ADDENDUM #2

March 11, 2016

Food Lab Renovations at North Buncombe & Clyde A. Erwin High Schools Food Lab Renovations at Enka High School Buncombe County Schools, Asheville, NC

REVISED DETAIL, ERWIN SHEET A2.1

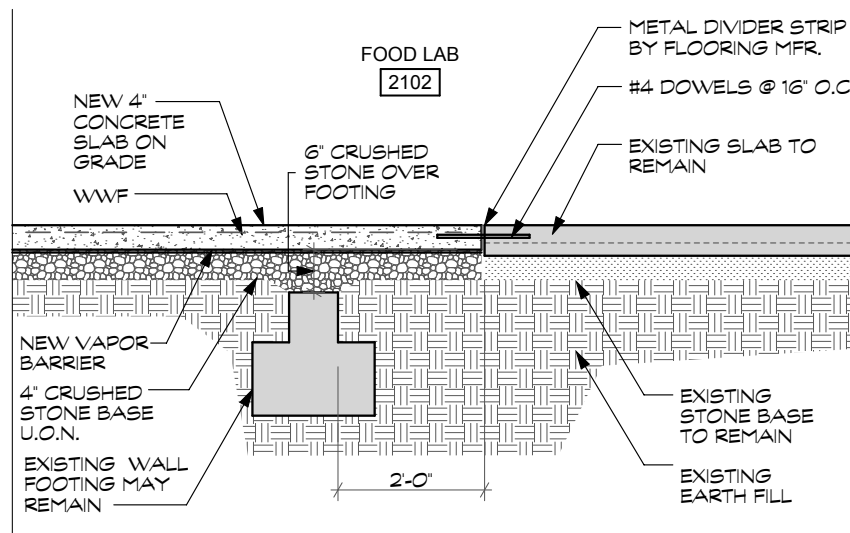
Refer to the Drawings for Erwin High School, Sheets D1.1 and A2.1. For bidding purposes, existing slabs on grade are 4" concrete reinforced with WWF, installed over a vapor barrier over 4" crushed stone. Replace Detail 3/A2.1 with the revision shown below. 6" stone base is required ONLY directly above existing footings which are left in place. In all other locations, 4" stone base is required. Unit prices have been added to the Project to provide a basis of compensation for accommodating existing conditions which do not meet this description - see Item 17, above.

NEW CONCRETE SLAB ON GRADE SHALL BE 4" THICK, 3,000 PSI, NORMAL WEIGHT CONCRETE INSTALLED OVER VAPOR BARRIER PER SPECIFICATIONS SECTION 03 3000. EXTEND VAPOR BARRIER MIN. 8" DOWN FACE OF EXIST. CONC. WALL. REINFORCEMENT SHALL BE 6 x 6 x W2.9 x W2.9 WWF, PLACED IN TOP THIRD OF SLAB AND NO MORE THAN 1" BELOW TOP SURFACE.

E2.1-1

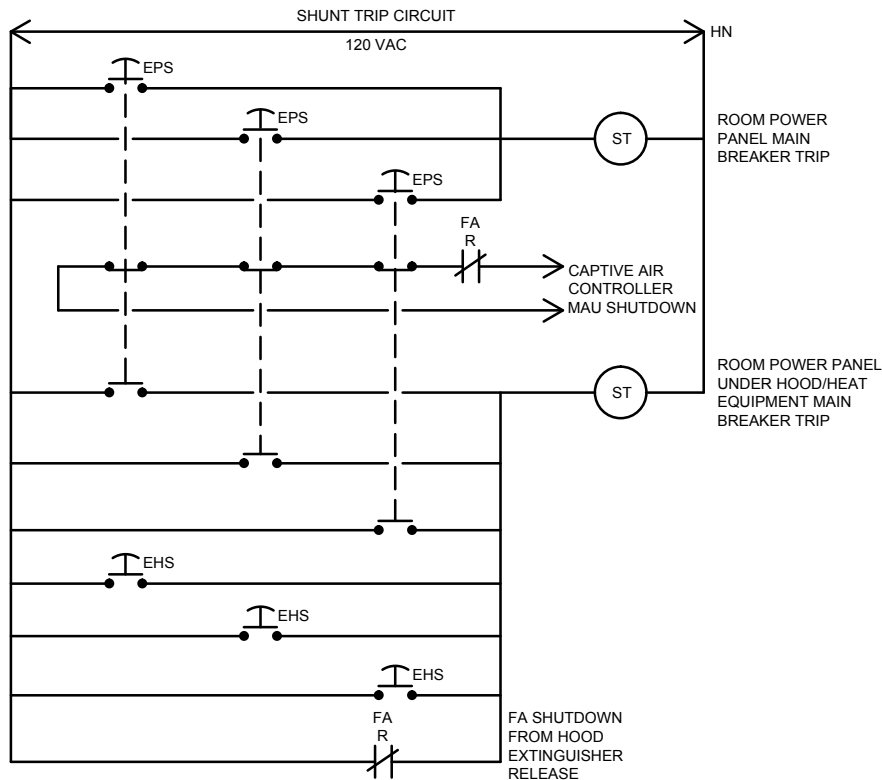
Provide Room "Emergency Power Shutoff" control per attached Bulletin BD-E2.1-1. This will also shut off the makeup air units for the hoods.

Refer to the Drawings, Erwin Sheet E1.1. Reference Food Lab Keyed Note 6 to Bulletin Dwg. BD-E2.1-1, attached. Shutdown controls must shut off two makeup air units.

Refer to the Drawings, Enka Sheet E1.1. Add Note 20 as follows: Provide Fire Alarm Relay on Makeup Air Unit Control Panel to shut down makeup air unit on evacuation alarm which is shown on "Emergency Power Shutoff" control. (General Item 26 Above). Use local NAC circuit.

ST: SHUNT TRIP
 EHS: EMERGENCY HOOD/HEAT SHUTDOWN
 EPS: EMERGENCY ROOM POWER SHUTDOWN
 MAU: MAKEUP AIR UNIT
 NOTE: ENKA DOES NOT HAVE ST FOR HOOD EQUIPMENT. EHS IS NOT REQUIRED

ERWIN ROOF PLAN - GAS PIPING

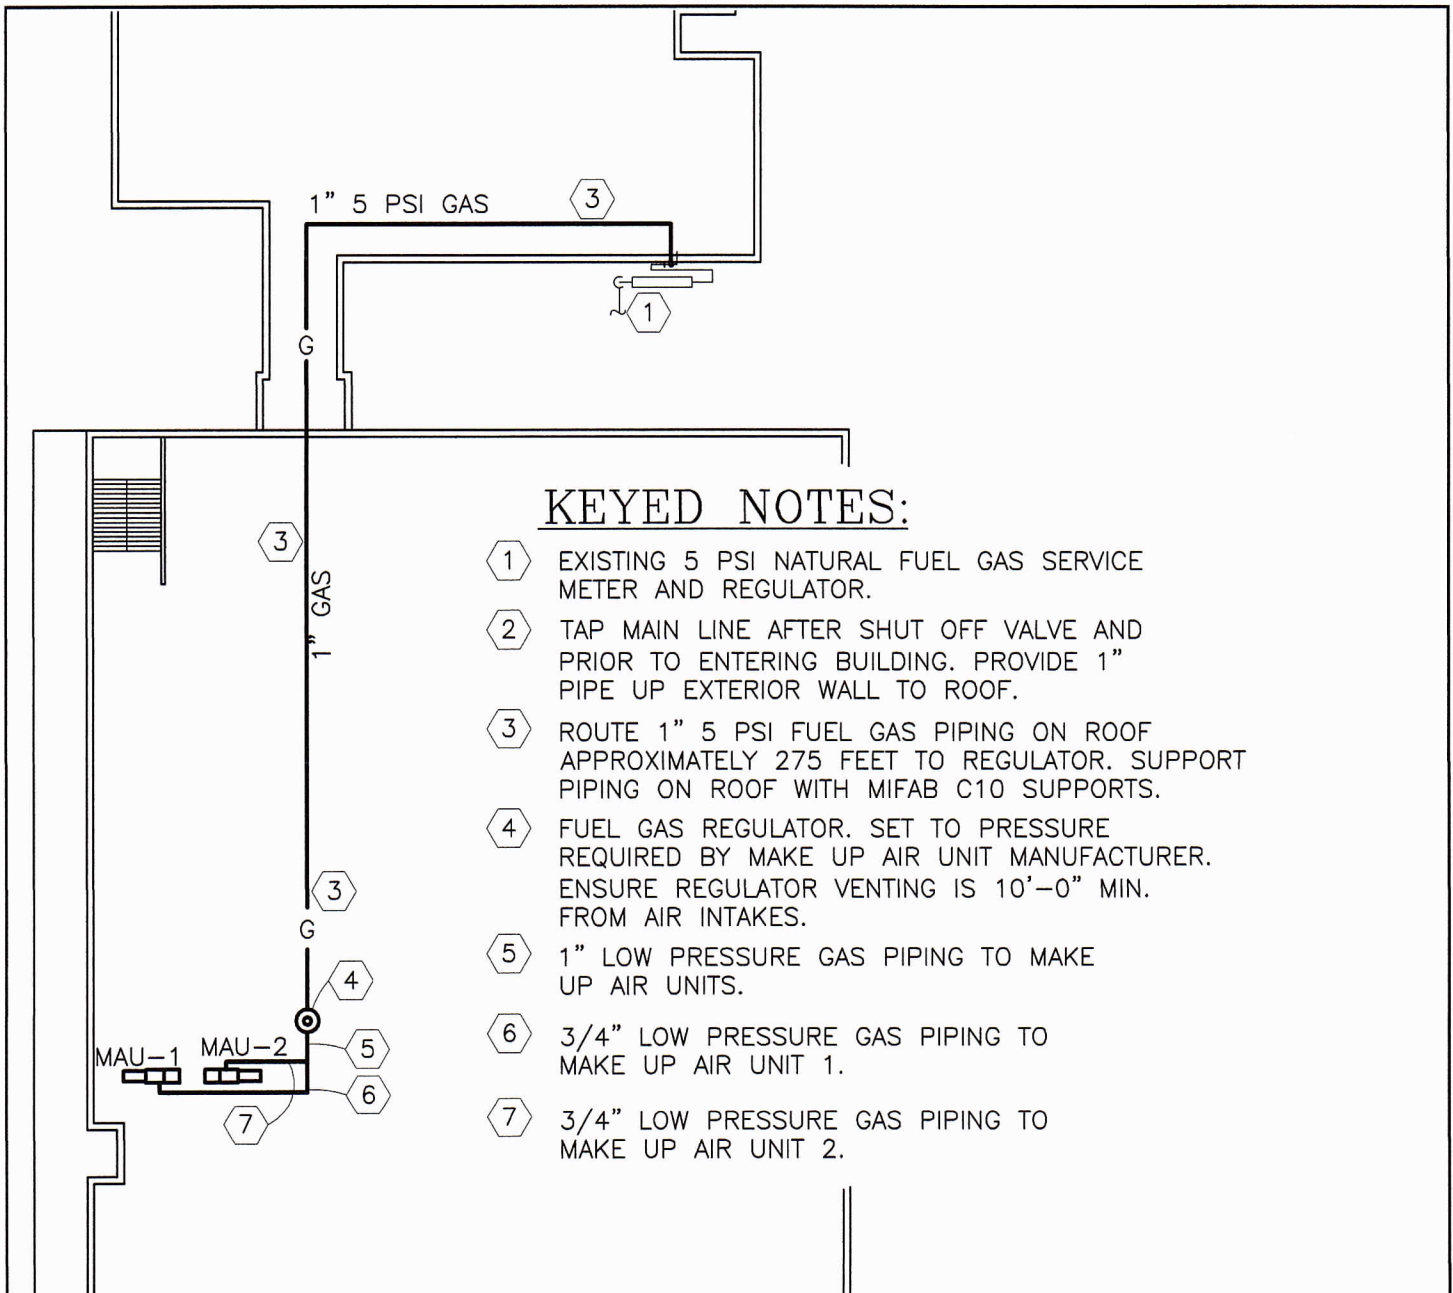
Refer to the Drawings, Erwin Sheet M1.3. Provide fuel gas piping on roof for make-up air units as shown on attached bulletin drawing, labeled "Erwin Roof Plan - Gas Piping."

ADDED FUEL GAS PIPING TO OVERALL ROOF PLAN - ERWIN HIGH SCHOOL

System No. C-AJ-7096

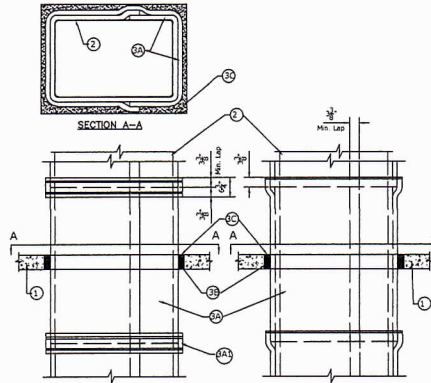
Refer to the Drawings, Erwin Sheets M1.2, M1.3. Fire rated duct wrap for grease ducting shall extend from the hood up through mechanical room to roof penetration. Chase in mechanical room is not required. See attached bulletin drawing, labeled "System No. C-AJ-7096" for penetration detail.

ADDED UL DETAIL FOR FIRE WRAPPED GREASE DUCT.
